UNITED STATES
NUCLEAR REGULATORY COMMISSION
WASHINGTON, DC 20555 - 0001

SUBJECT: SUMMARY OF THE APRIL 24, 2003, PUBLIC MEETING TO DISCUSS
THE DEVELOPMENT OF A PROPOSED WORKER FATIGUE RULE

DRAFT WORKER FATIGUE RULE LANGUAGE, REVISION 3

Self-Declaration

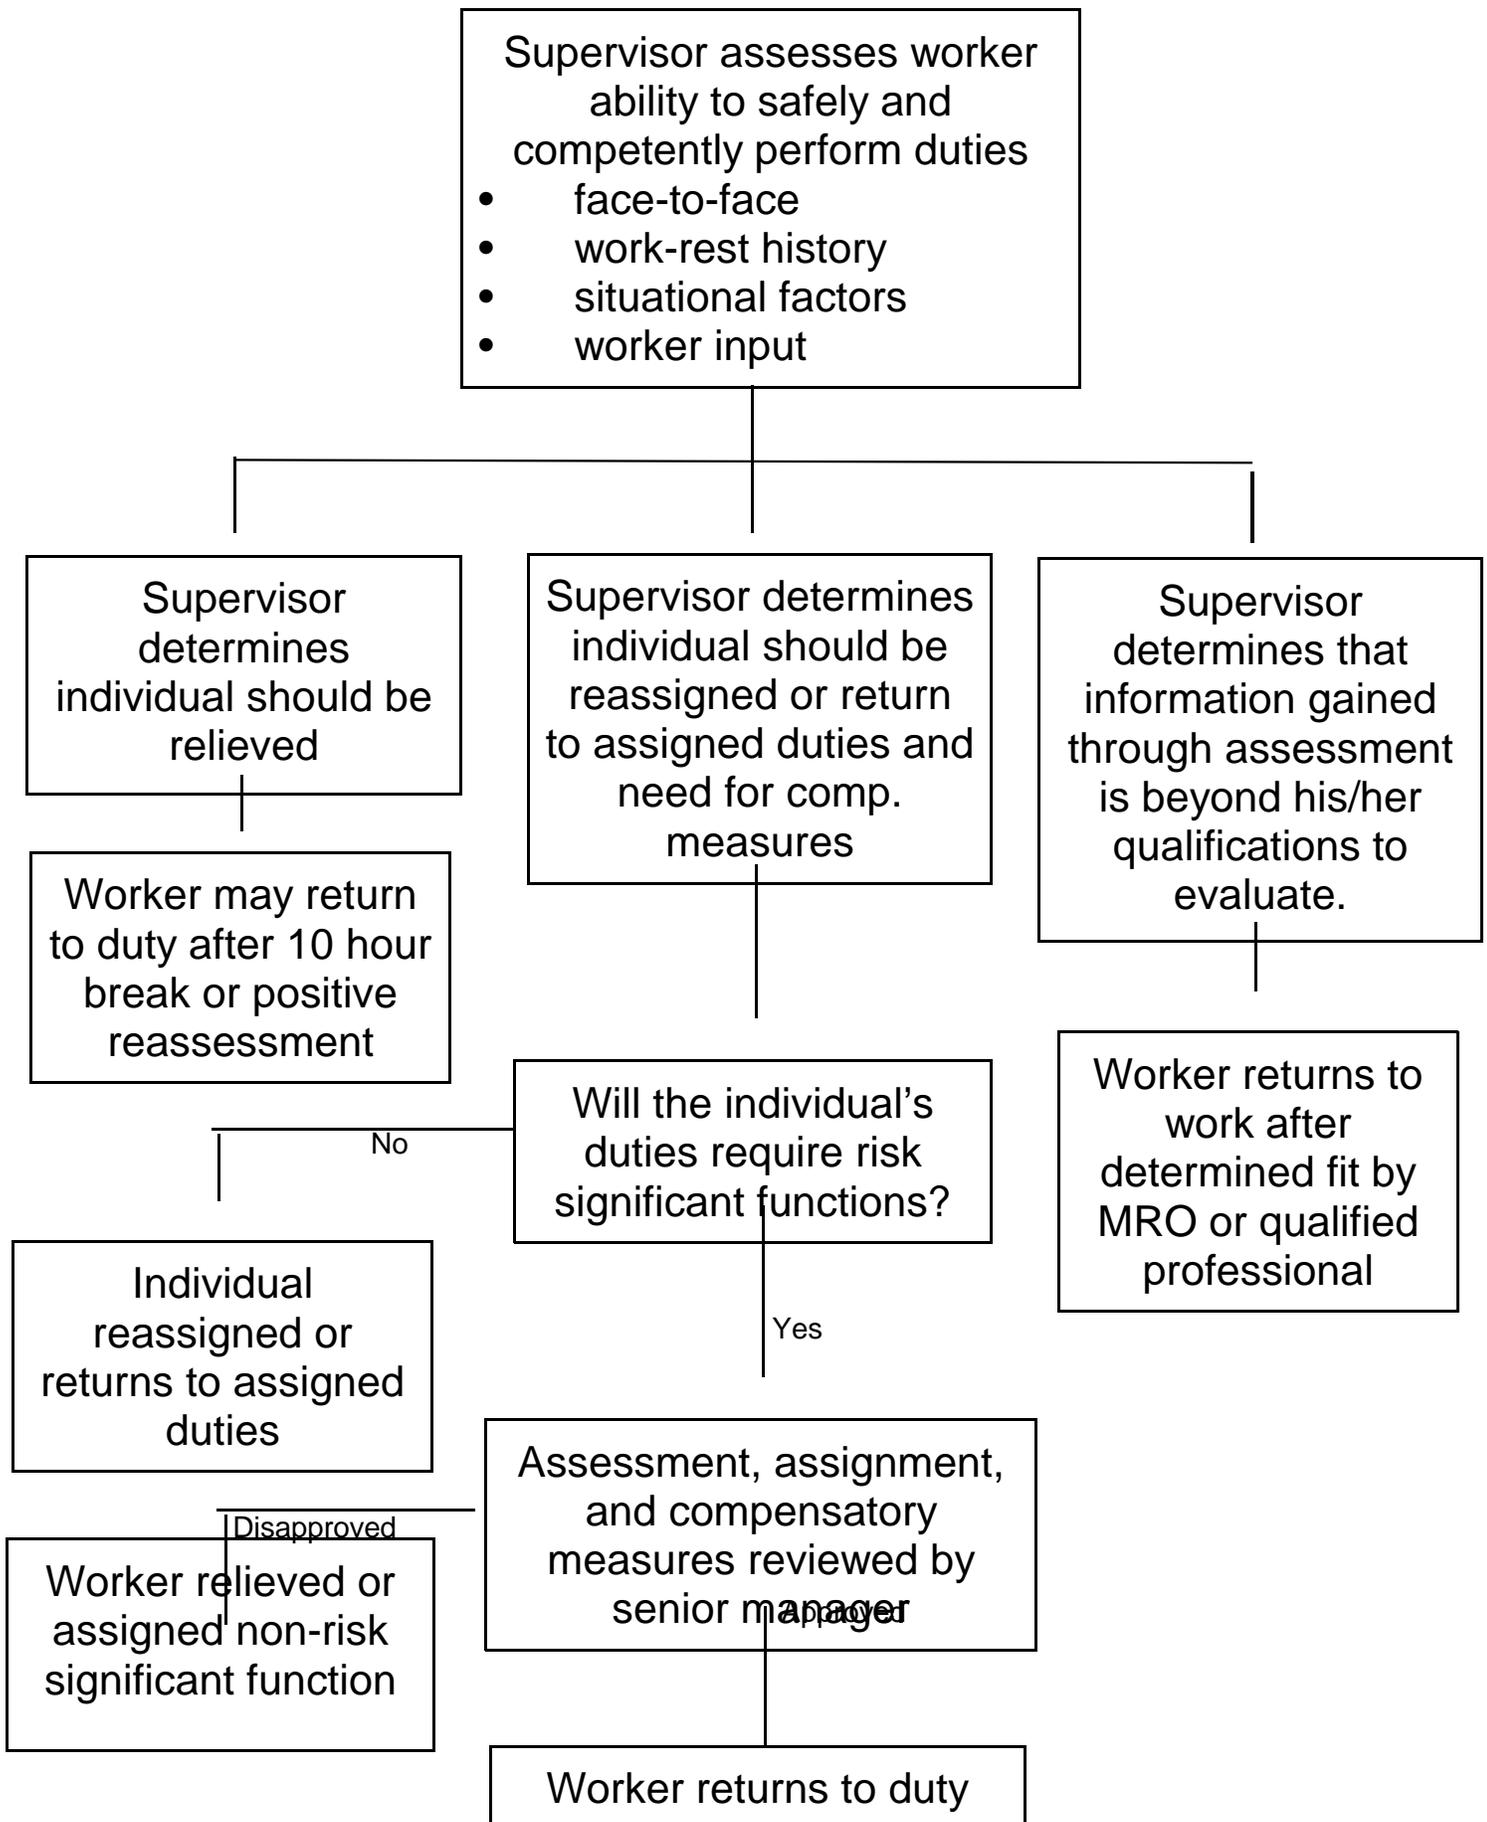
The chart should be restructured to indicate that response to a self declaration would not be within the scope of the Part 26 fitness for duty requirements unless there is a disagreement between the worker and supervisor concerning the fitness for duty declaration.

Documentation of self declarations could have a chilling effect.

Observation

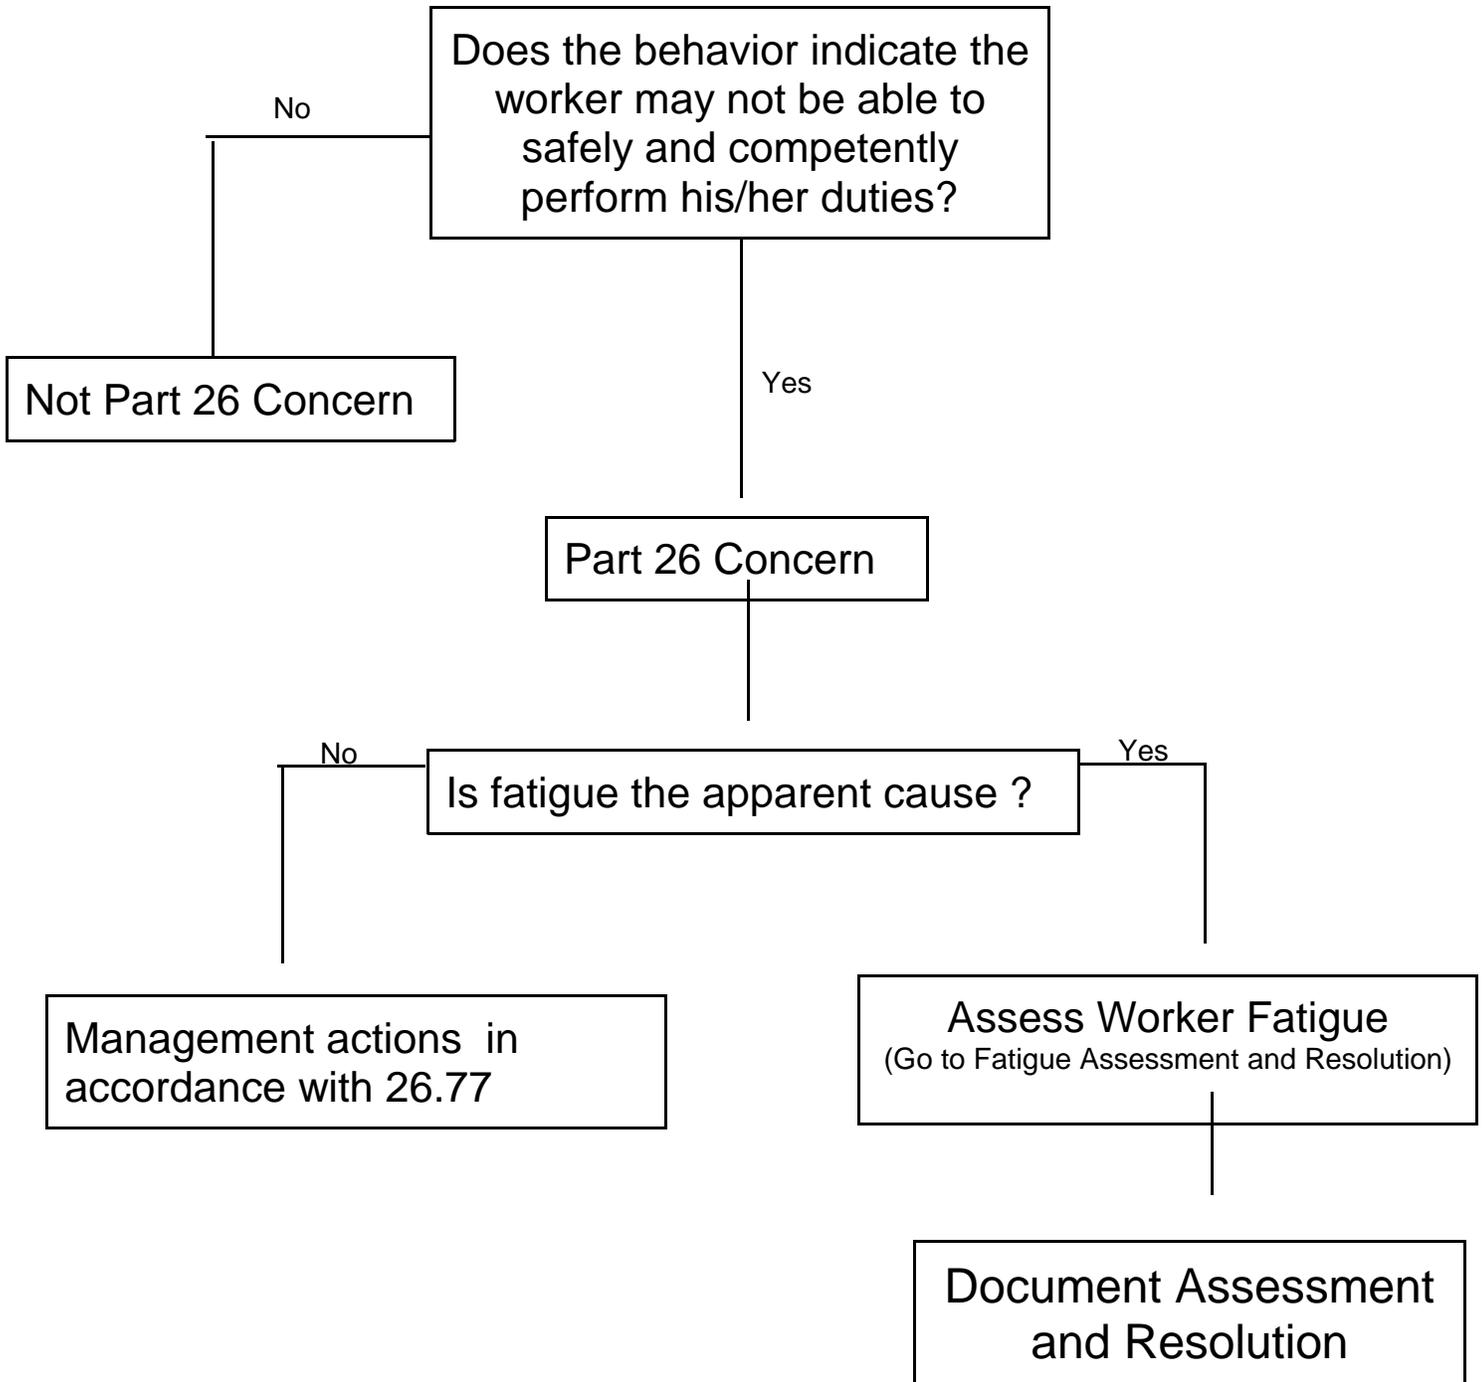
No substantive comments

Post-Event

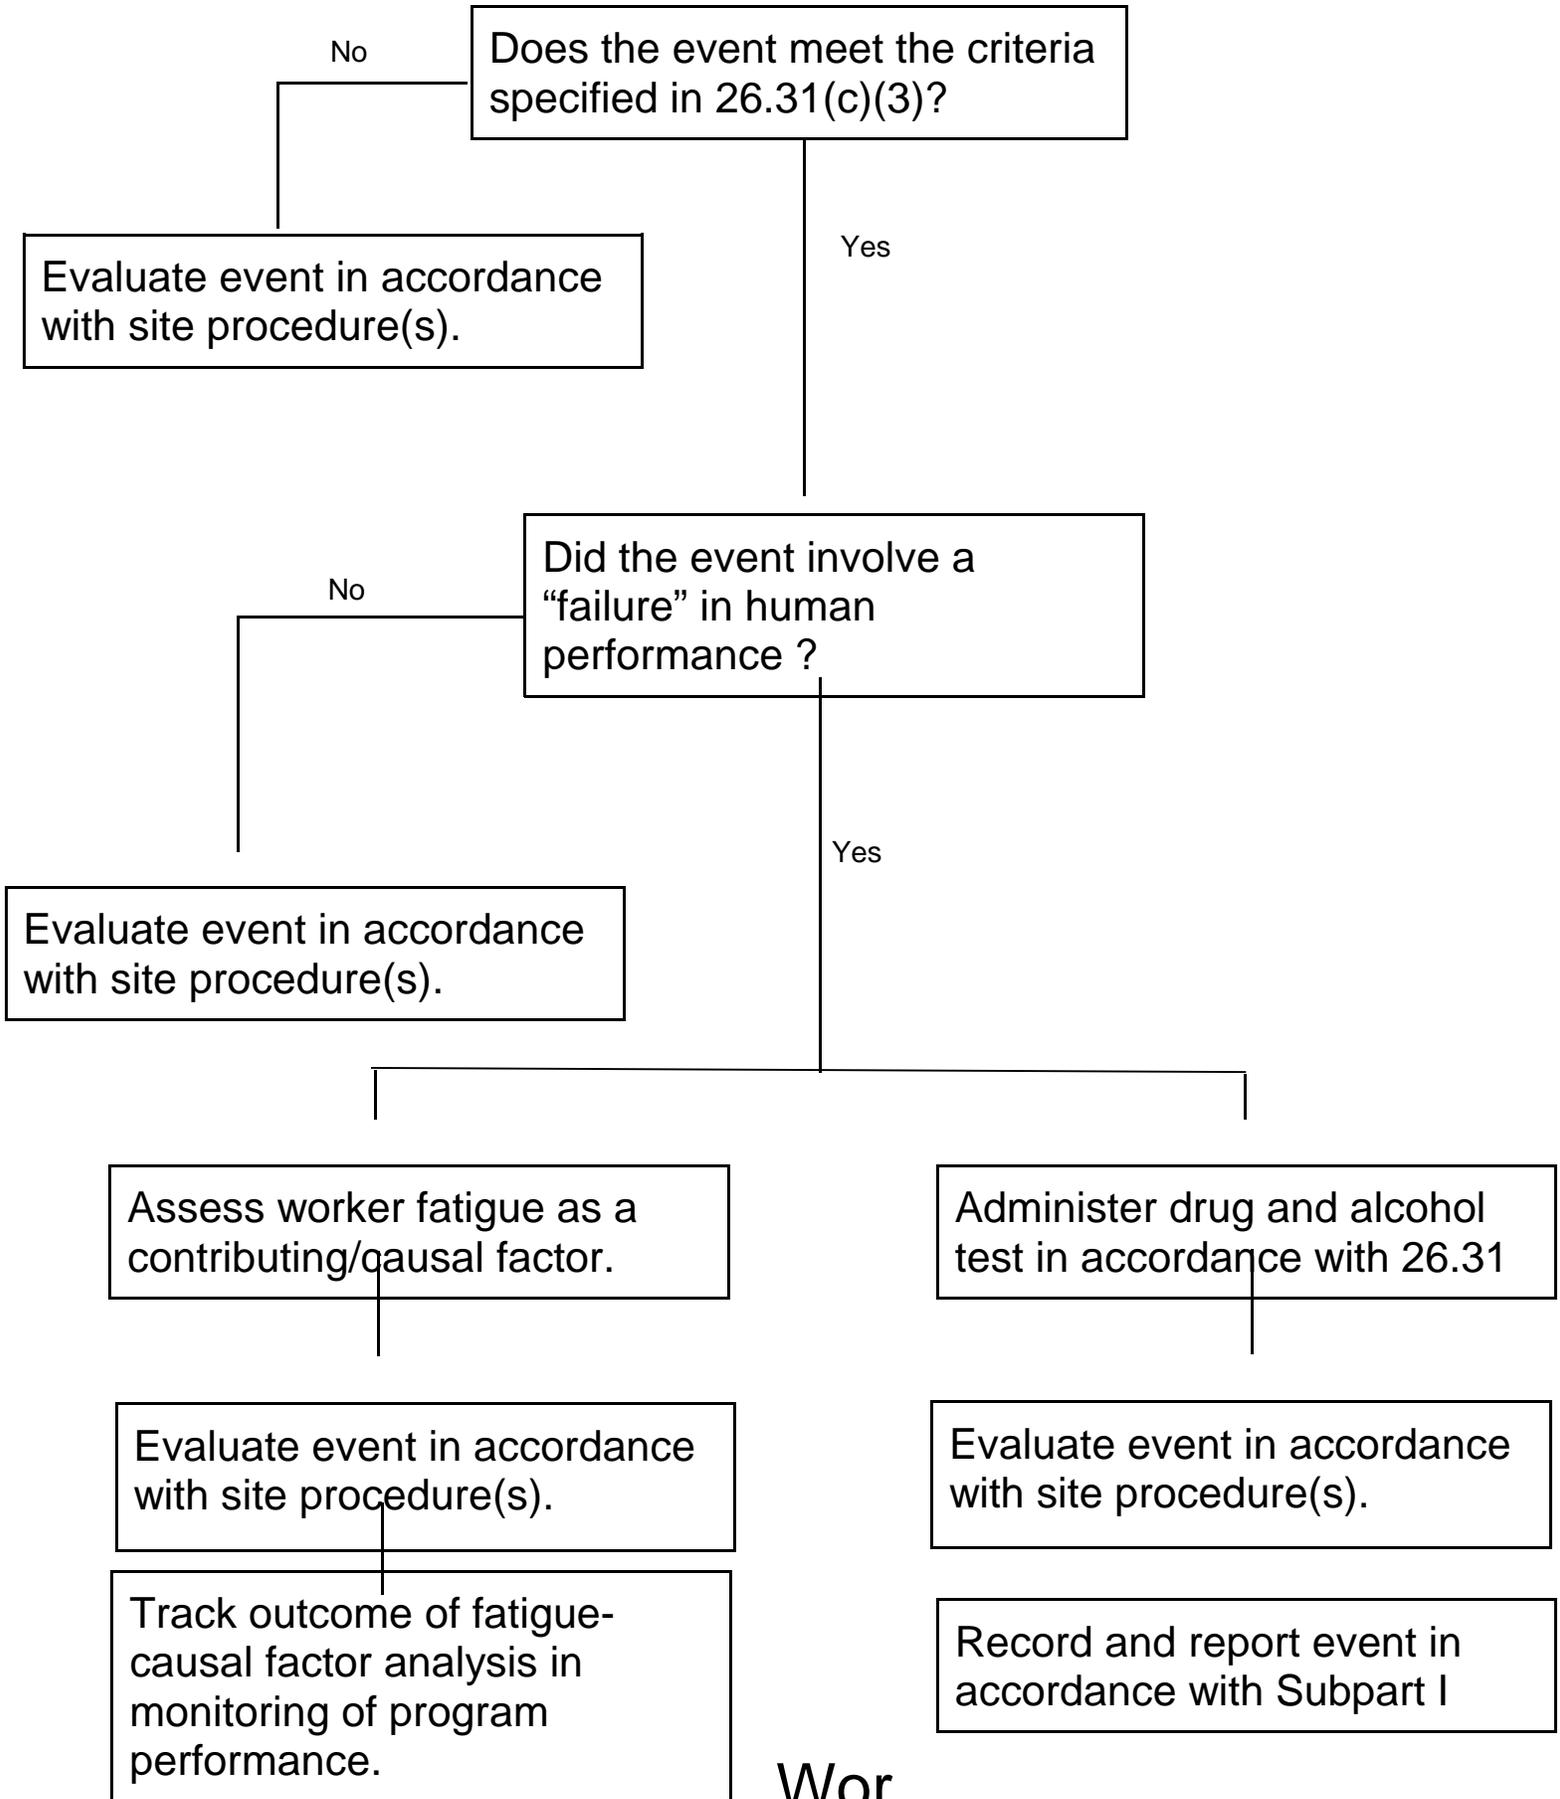
The decision “Did the event involve a “failure” in human performance?” is not needed because this criterion is addressed within the first decision box, “Does the event meet the criteria specified in 26.31(c)(3).”

k Hours in Excess of Threshold

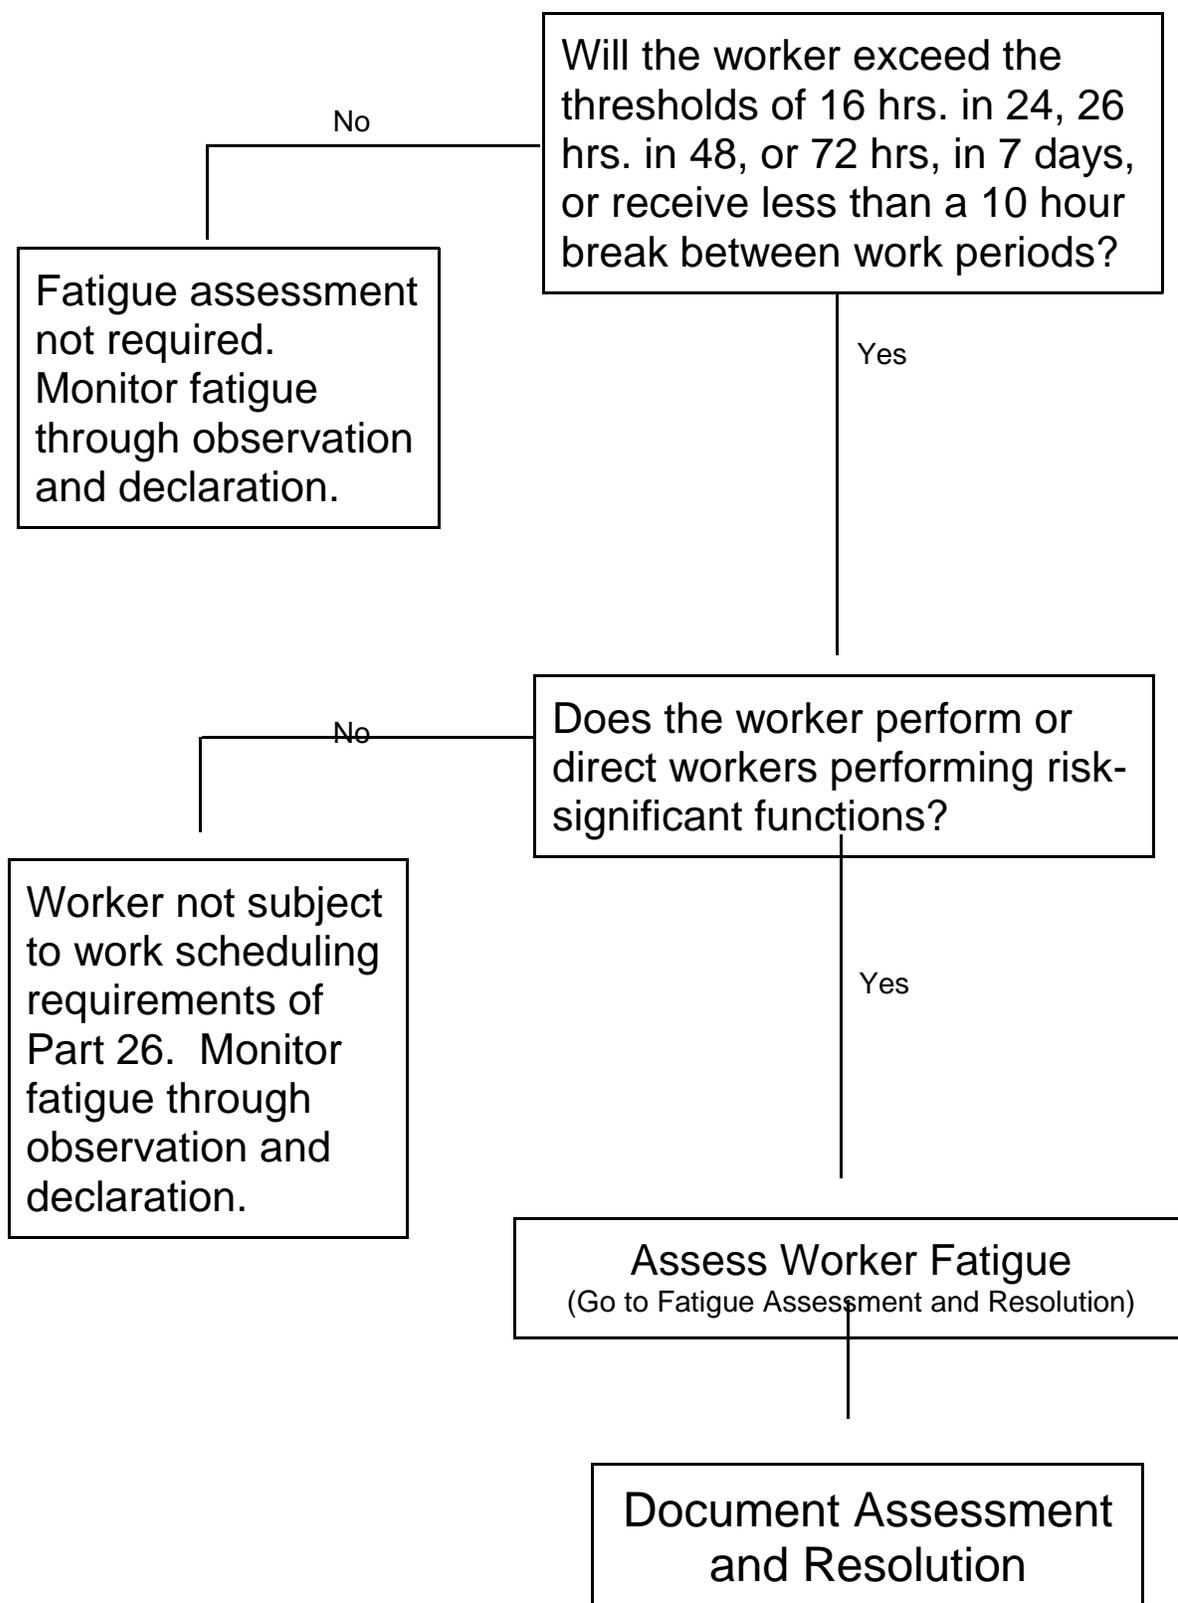
The chart should be restructured to have the first decision box address whether or not the worker performs functions subject to work hour controls as specified in 26.30(a) of the draft rule language.
